Product Change Notice  
 PCN Tracking Number: TMJ-PP-0813

Size	Resolution	Type name
15.3"	WXGA	NL12876BC26-32D

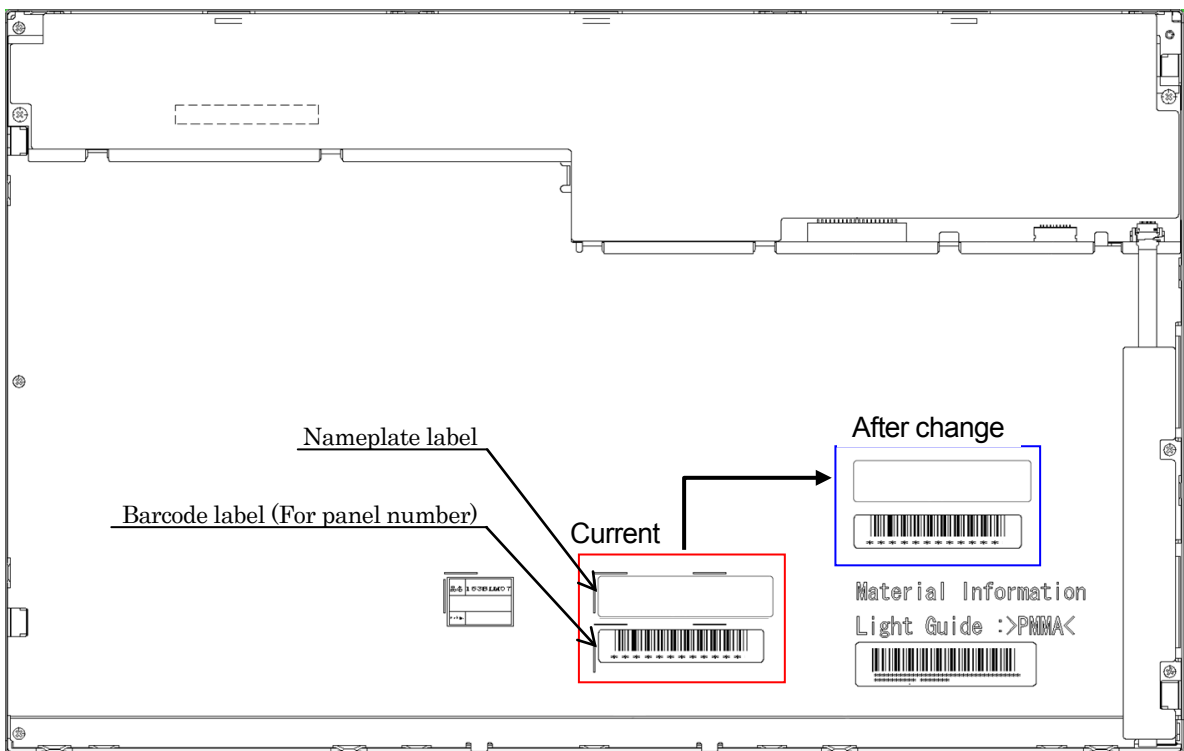
In order to improve the productivity by standardization of work, the position of labels on the bottom side of product will be moved.

There are no optical, mechanical or electrical specifications change and no changes in product reliability. And there will be no influence on UL approval and RoHS compliance.
